Hassell

URBAN DESIGN REVIEW WATERLOO ESTATE SOUTH

1.	Introduction	3
2.	Place Analysis	9
3.	Observations on the Planning Proposal	33
4.	Technical Analysis of Planning Proposal	67
5.	Recommendations Summary	133
6.	Peer Review	151
7.	Appendices	
	Design guideline drawings	157
	Shadow drawings	201
	Area schedule	205

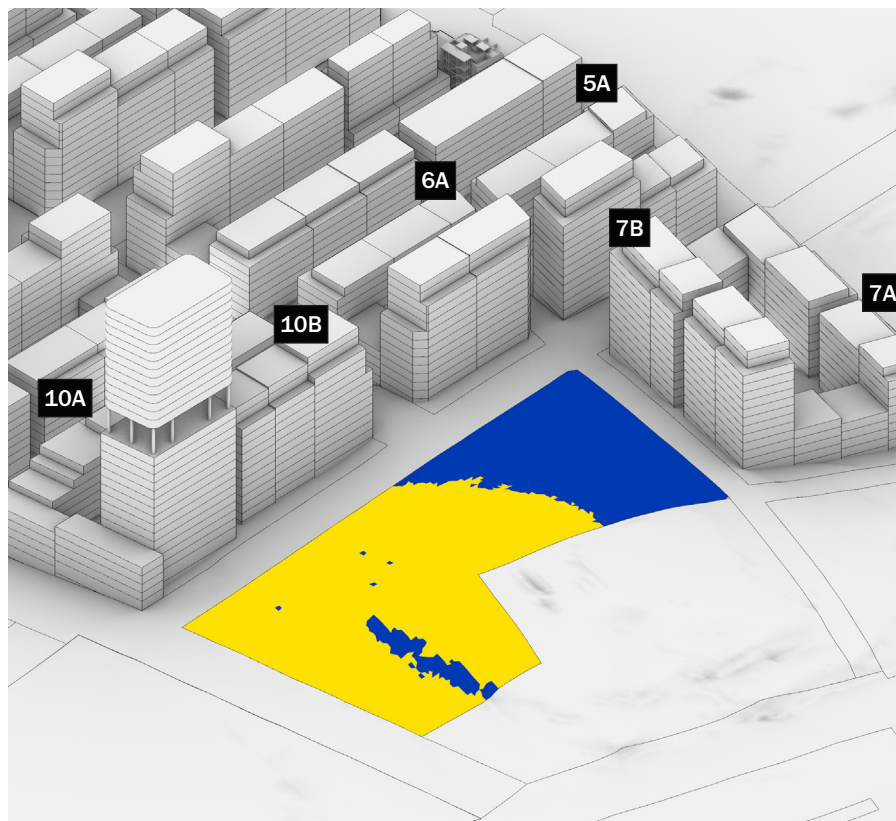
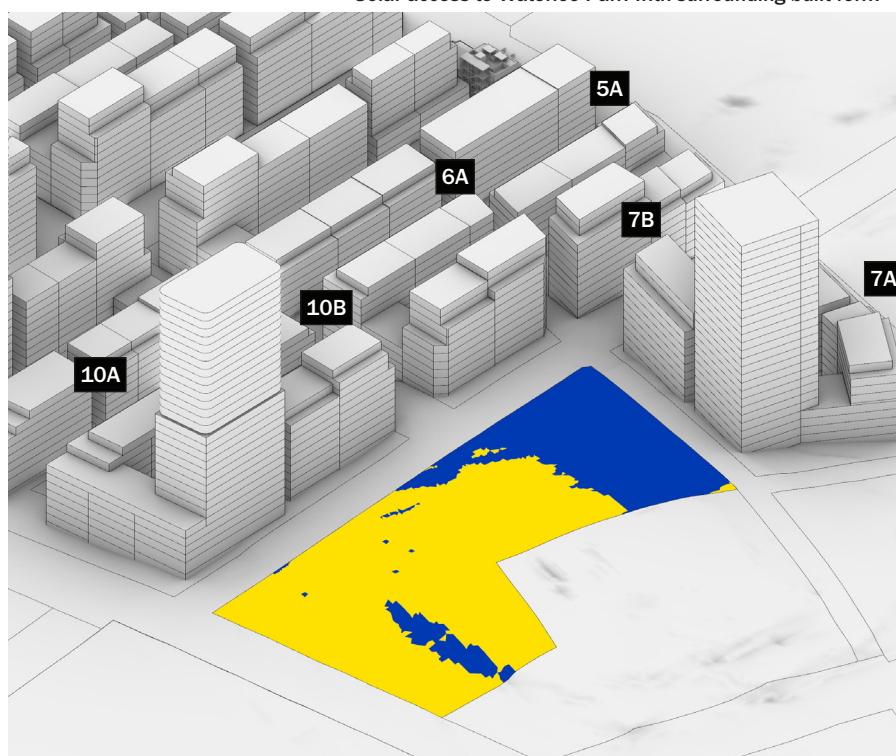
The drawing to the right shows the planning proposal as having:

- In Shadow = 38% / 4836 sqm
- In Sun = 62% / 7812 sqm
- (A minimum of 4 hours+ of 50% of solar access required in winter)

The amended building envelope has a marginally improved outcome:

- In Shadow = 37% / 4685 sqm
- In Sun = 63% / 7963 sqm
- (A minimum of 4 hours+ of 50% of solar access required in winter)

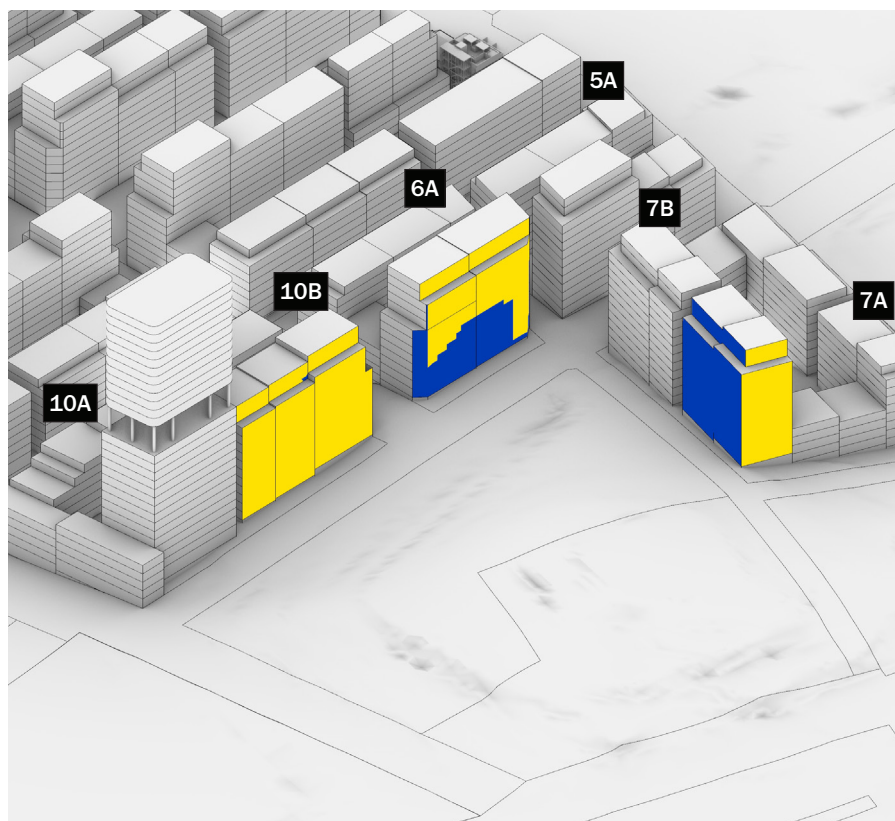
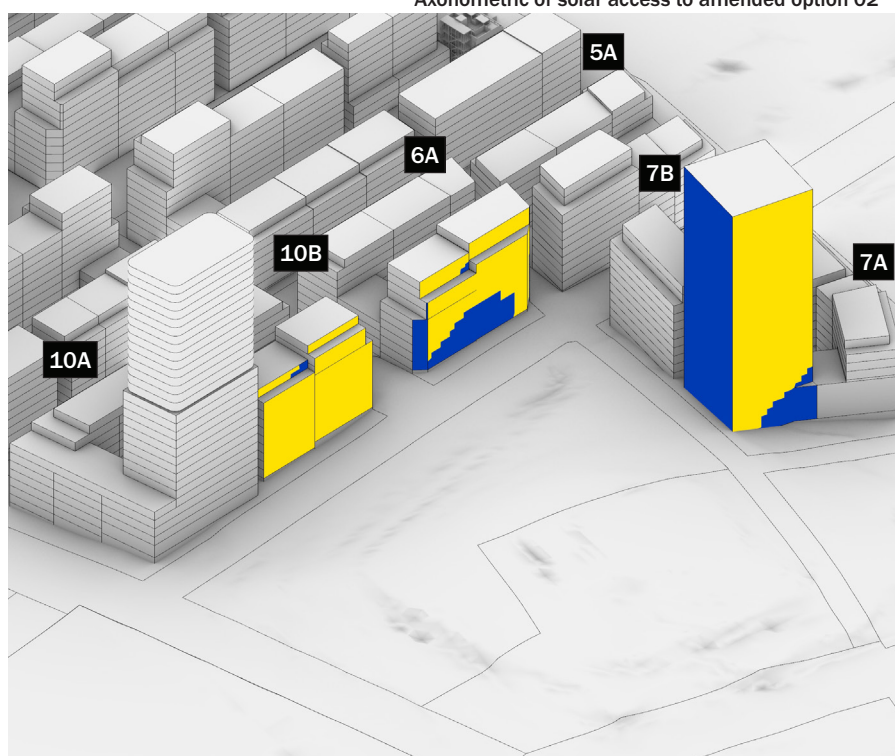
The drawing to the right shows the planning proposal impact to the street facades of future residential development:

- **Block 6A:**
 - In Shadow = 36% / 735 sqm
 - In Sun = 64% / 1290 sqm
 - (A minimum of 2 hours+ of 50% of solar access required in winter)
- **Block 10B:**
 - In Shadow = 0.5% / 10 sqm
 - In Sun = 99.5% / 2158 sqm
 - (A minimum of 2 hours+ of 50% of solar access required in winter)

The amended building envelope has an improved outcome:

- **Block 6A:**
 - In Shadow = 31% / 508 sqm
 - In Sun = 69% / 1130 sqm
 - (A minimum of 2 hours+ of 50% of solar access required in winter)
- **Block 10B:**
 - In Shadow = 2% / 26 sqm
 - In Sun = 98% / 1444 sqm
 - (A minimum of 2 hours+ of 50% of solar access required in winter)

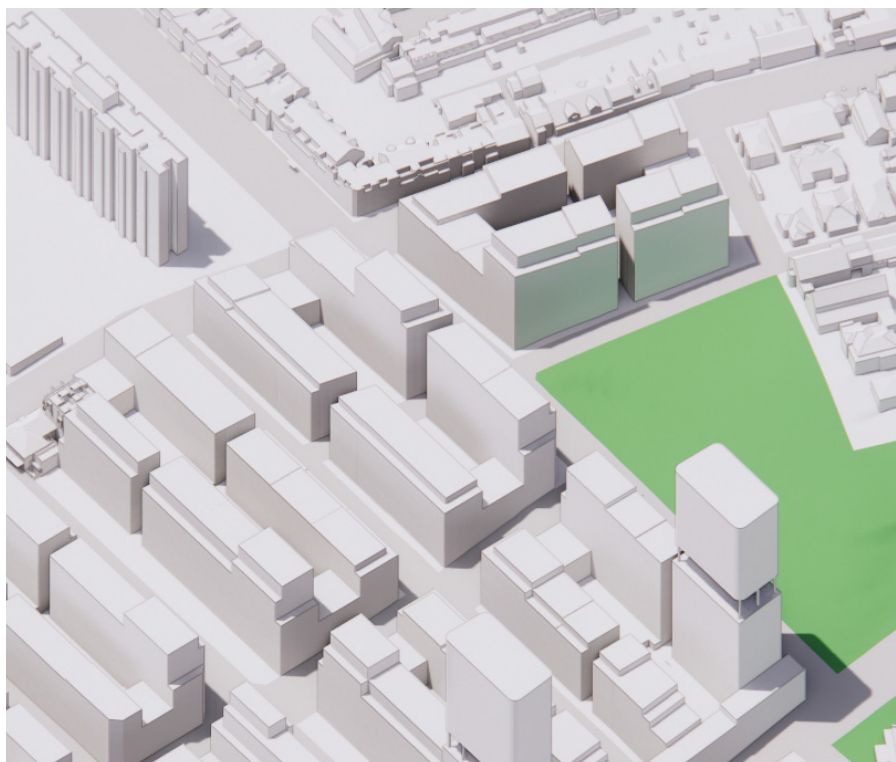
**The planning proposal
13 storey interface
to Waterloo Park and
adjacent residential terrace
houses.**

View from Redfern Park looking south west

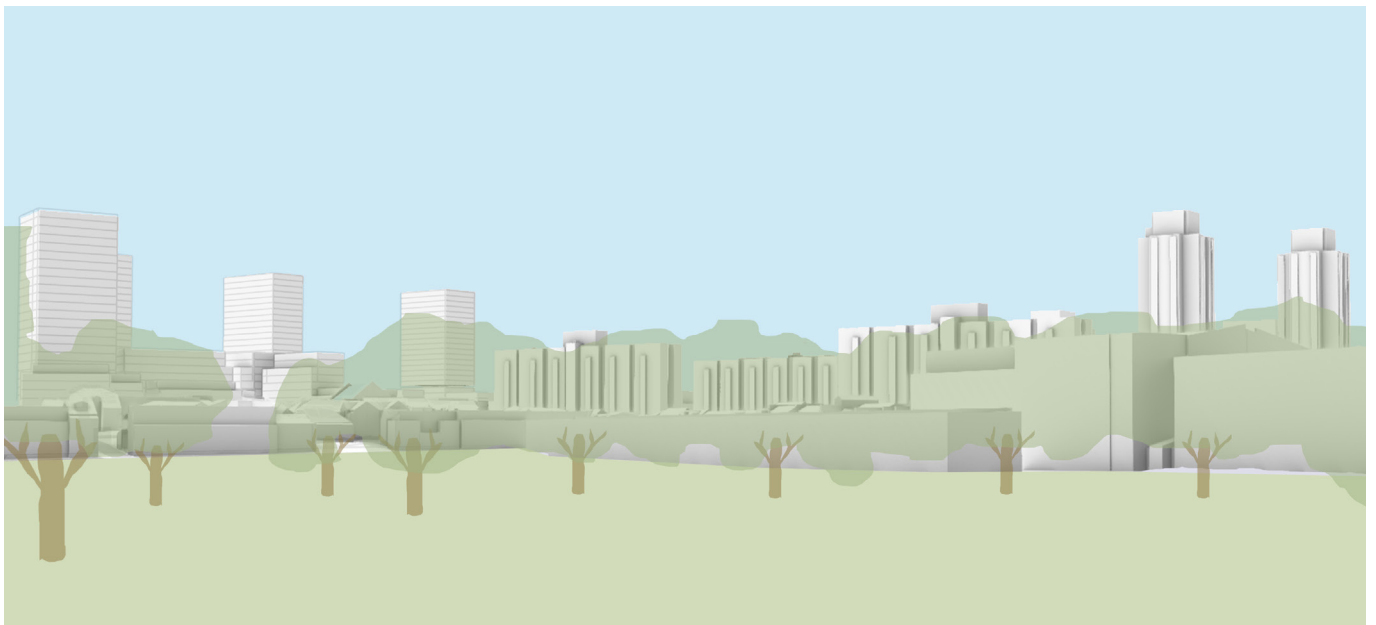
Above, City of Sydney proposal
Below, Amended envelope

View from Alexandria Park looking east

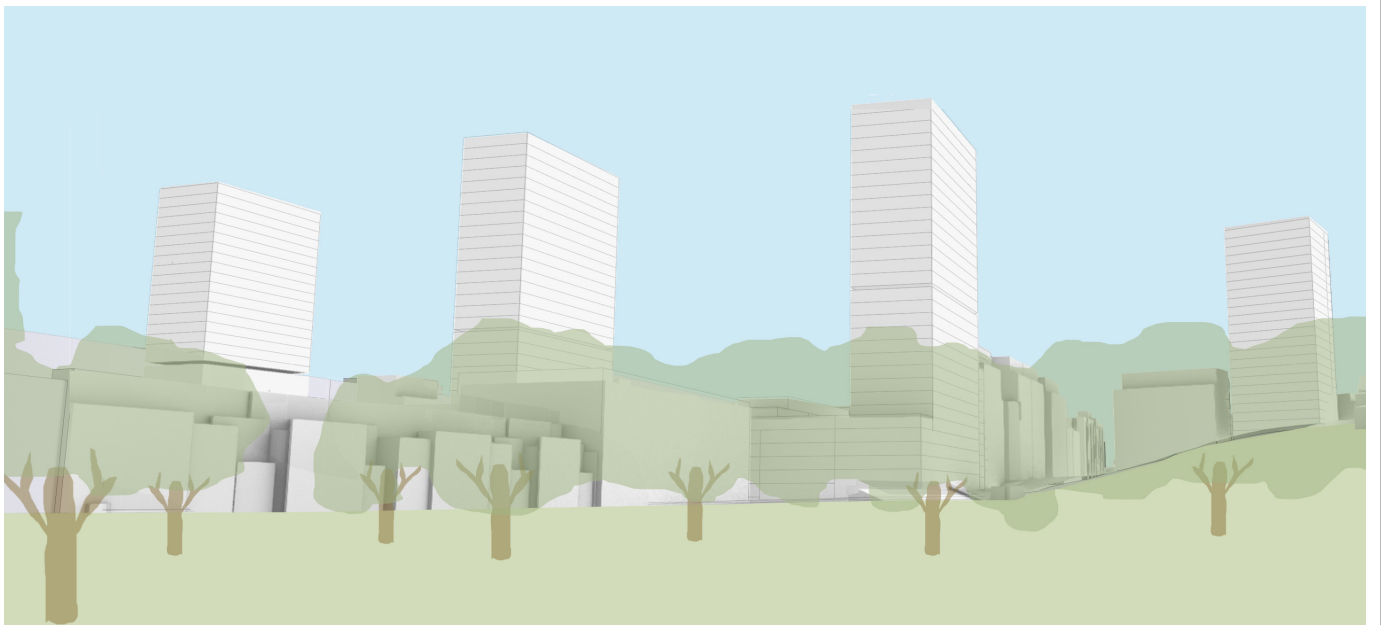
Above, City of Sydney proposal
Below, Amended envelope

View from large park looking south

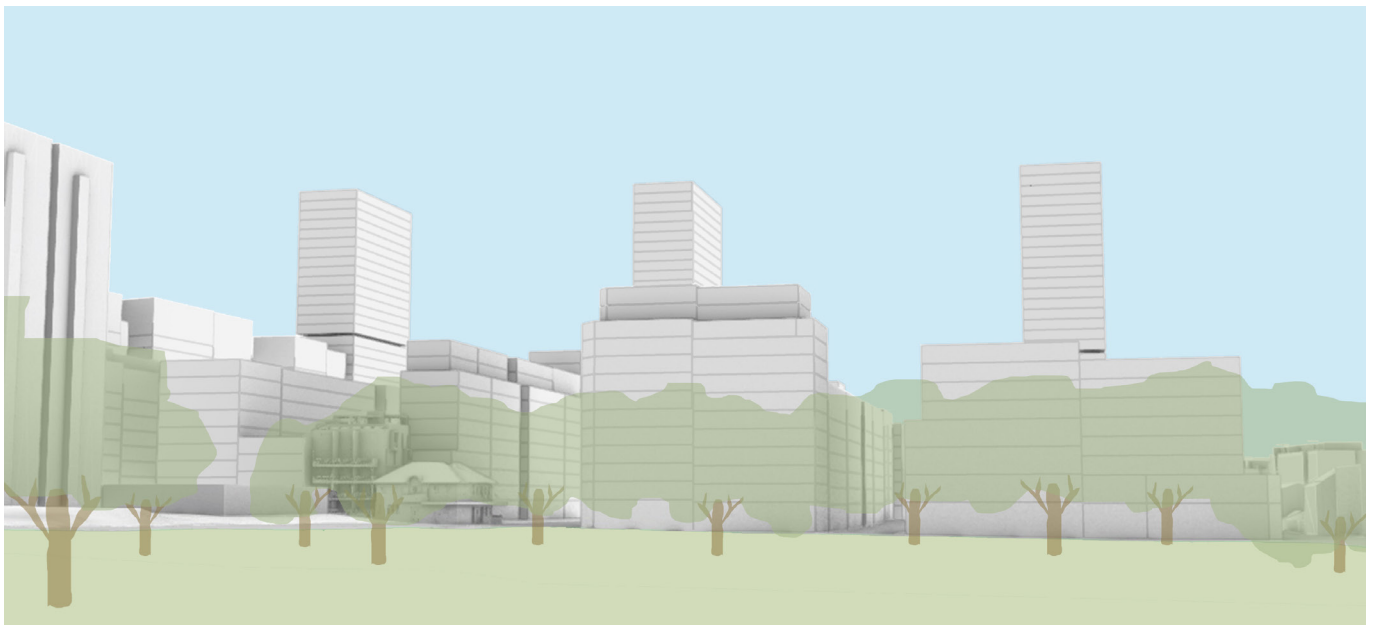
Above, City of Sydney proposal
Below, Amended envelope
